## **BOUNTIFUL CITY PLANNING COMMISSION**

### **AMENDED AGENDA**

# Planning Commission Staff Report

**Subject:** Renaissance Towne Centre Lot 11 - Development Plan Amendment  
**Property:** 1791 South Renaissance Towne Drive  
**Author:** Francisco Astorga, AICP, Planning Director  
**Date:** September 20, 2022

View from mid-block 1800 South looking northeast (corner of 1800 South and Renaissance Towne Drive).

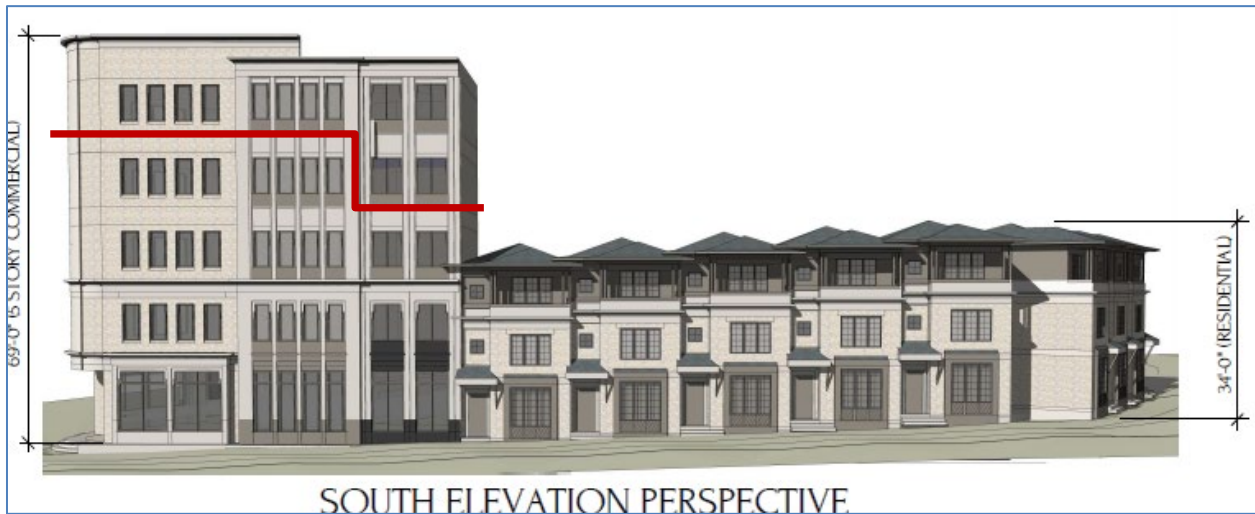
Staff finds that the transition from the proposed townhouses, at approx. 35' around the non-residential building, to 69' is too drastic and that additional massing mitigation would be appropriate based on the proposed development pattern from the townhouses to the non-residential building. Staff recommends mitigating the change by dropping the proposal of the non-residential building to four (4) stories instead of five (5) with an approx. building height of 55 feet and considering a pyramid effect transitioning to approx. 45 feet back and then back to 35 feet of the proposed townhouses, see diagram below.

Staff finds that this mitigation would help the effects of the difference in height in the two (2) types of buildings and softens the transition. The non-residential node is not adjacent to single-family residential (max. height of 35 feet) east of Main Street. Staff does not recognize any possible of issues of negatively affecting the car dealership on 1800 South in the General Commercial (C-G) Zone (max. height of 45 feet) found in Staff's recommendation. Based on the proposed location of the non-residential building, Staff supports the height amendment for the non-residential node as described herein with an approximate building height of 55 feet transitioning to 45 feet as the building gets closer the proposed townhouses. Staff's recommendation also applies to the west elevation, Renaissance Towne Drive.

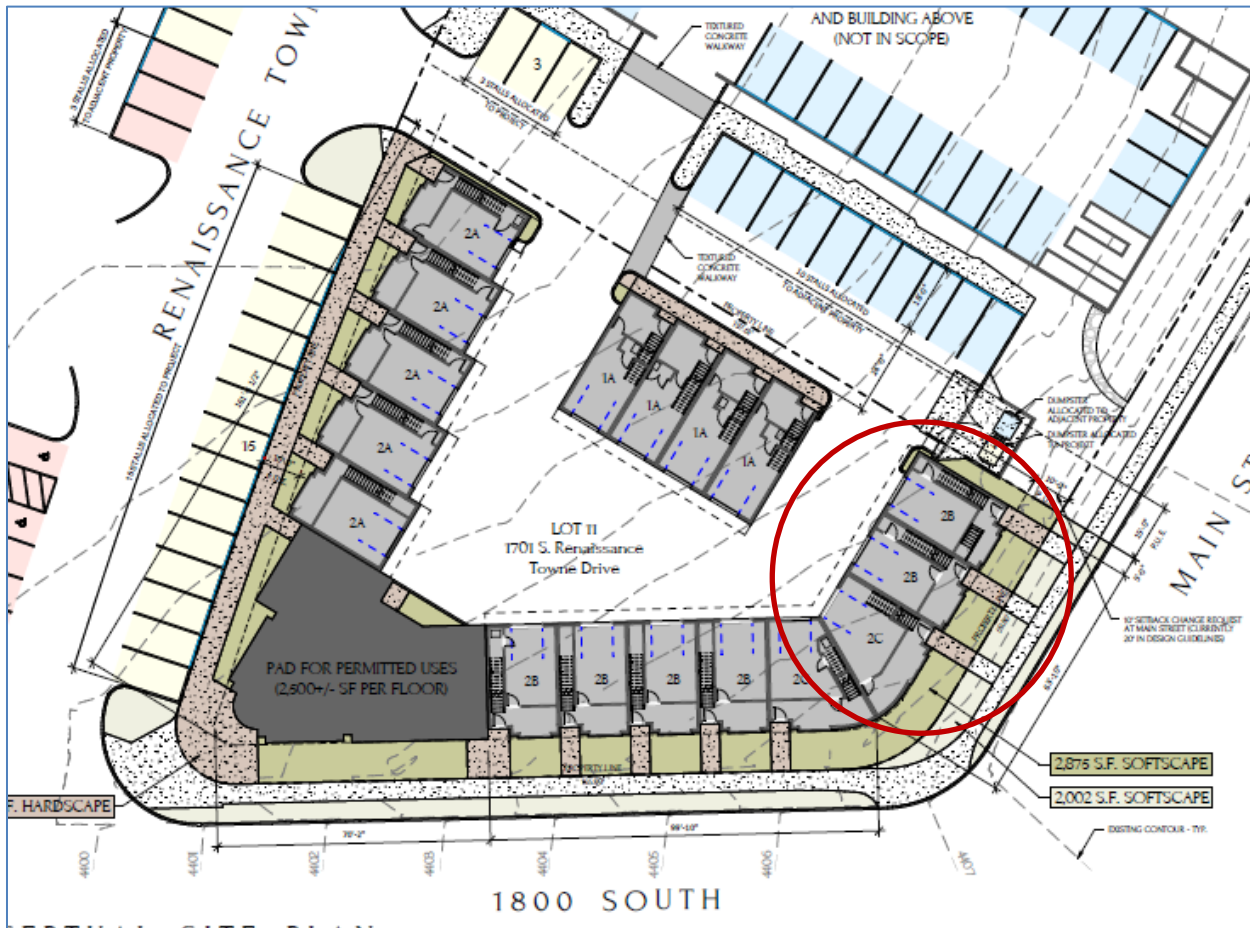
Planning Staff supports the proposed reduced Main Street setback of 20 feet to 10 feet for the three (3) proposed townhouses as illustrated below:

Planning Staff finds that the proposed setback for these three (3) specific townhouses is mitigated based on their proposed building height, approximately 35' which provide a soft transition from the maximum allowed height across Main Street towards the east (limited at 35').

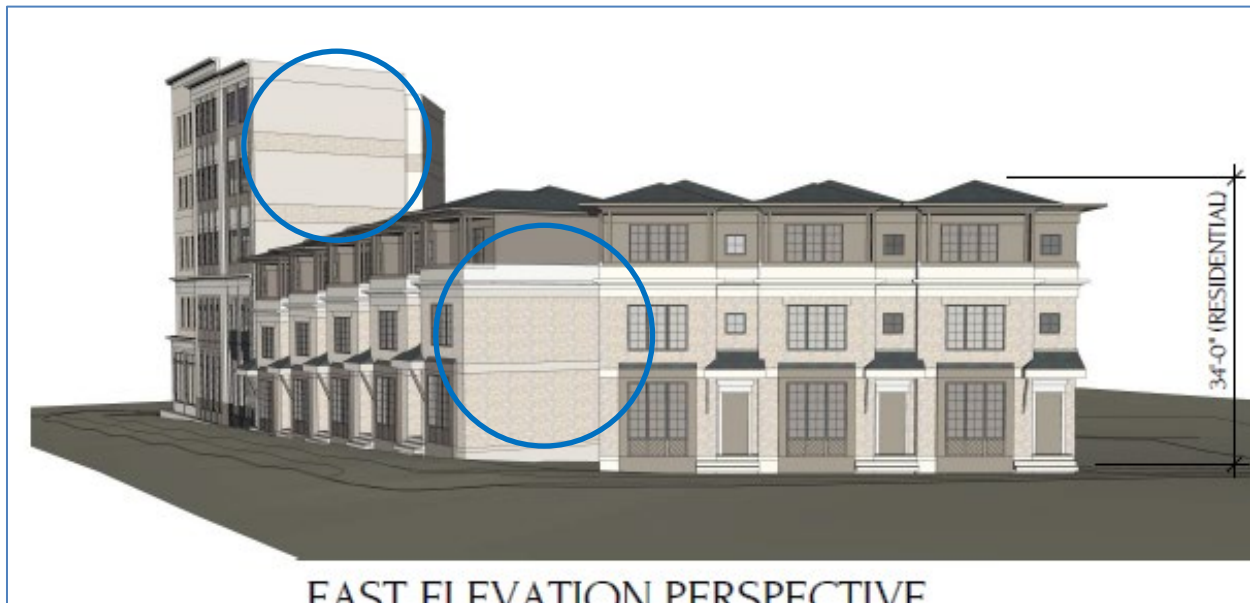
perspectives. Staff recommends adding windows on side of the buildings that are exposed to Main Street (shown below), 1800 South, and Renaissance Towne Drive.

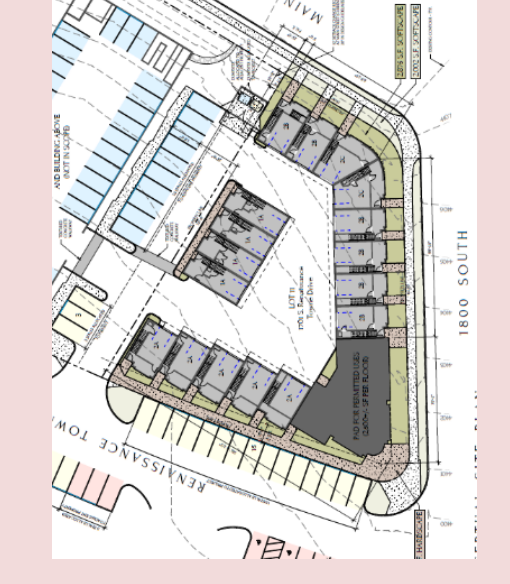
Staff recommends the removal of the four (4) 1-bedroom apartment building towards the middle of the development. This small area can accommodate a community gathering space or similar. While Staff supports the diversity in housing type in the introduction of townhouses to the overall development, Staff also recognizes the inefficiency of townhouses compared to an apartment building regarding site circulation (pedestrian/vehicular), access, usable open space, etc., mainly overtaken by the vehicular access to accommodate the 17 townhouses. While it can be shown that open space requirements are met, the site plan itself illustrates the unusable nature of the proposed open spaces and how its not suitable for actual use from future residents. The provided open space is mainly located within the required front yard setback with a miniscule amount of soft open space found in the “interior” portion of the site.

While the removal of the proposed 1-bedroom unit building, as recommended by Staff, does not decrease the approx. driveway area of the proposal currently corresponding to 30% of the site, it provides an opportunity for usable open space, in the form of a possible community gathering space. This recommendation allows for further mitigation of the newly requested amount and location of vehicular circulation, which was not discussed in the past as townhouses were not proposed.
